MetroNews

Tuesday June 26, 2007

NEW FL Tile Rake Metal – Stone-Coated Finish

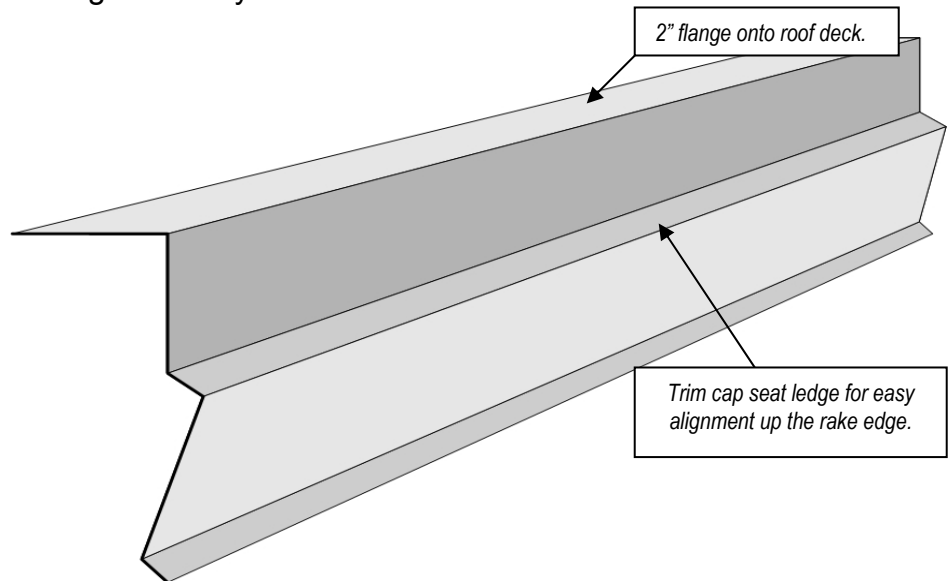
We have upgraded our Tile Rake metal flashing to a Stone-Coated version with a full 2”-inch flange that seats onto the roof deck to satisfy Florida installers.

This new part uses substantially more metal and being stone-coated, is priced accordingly, however the new part ensures a stone-coat finish up the rake edge to marry with stone-coated fascia.

The new FL Tile Rake Metal can be used with Metro Tile, Roman or Shake panels at the rake to perfectly align rake trim caps and provide a stone-coat finish to this area. The new Tile Rake Metal flashing in standard stone-coat colors will be in production during June-July 2007. The new part number is noted below.

Metro will carry a small quantity of the old PAINTED shape as we transition to this new version. Make sure you define which parts you need especially if you are matching to your inventory for job-lots.

Due to the differences between each part it's recommended that you do not mix the two in inventories or on job-lots.

ITEM X LENGTH	PN-# - XX = Color	INVOICE INFO
Existing PAINTED - Tile Rake Metal Flashing X 120"	3236-XX	
NEW Stone-Coated 'FL Tile Rake Metal' Flashing X 79"	3112-XX	'FL Tile Rake Metal'
